ADDENDUM #5

INVITATION TO BID
Town of East Windsor
Community Center Alterations and Additions
28 Abbe Road
East Windsor, Connecticut

PARTITION TYPES

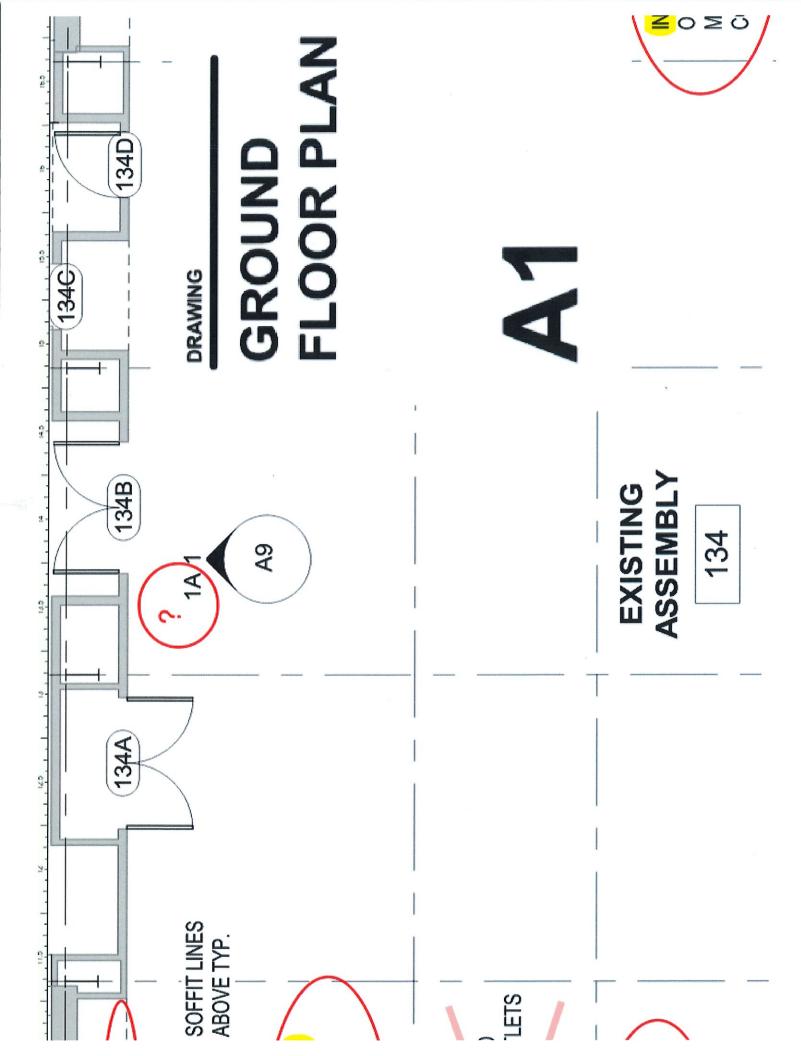
- 1. Confirm the mandatory pre-bid meeting held on 10-19-2023 was just for primes and not subcontractors. It was open to the public and anyone interested in bidding the work.
- 2. Provide back box type and cable needed for the T.V. Low profile 5x8 inch TV Box.
- 3. Provide length and description of the tape light in assembly room as it is not shown on the drawings or the fixture schedule. The led tape style light strips are set in a metal channel are installed along the top and width of the Existing Assembly room windows.
- 4. On Ground Floor Plan (A1), the only "1A" I have found is next to the door 134B. That number is the interior elevation view number nothing to do with partition. See Attachment.
- 5. Could you clarify which partitions are "1A"? Partition type 1A is not used.
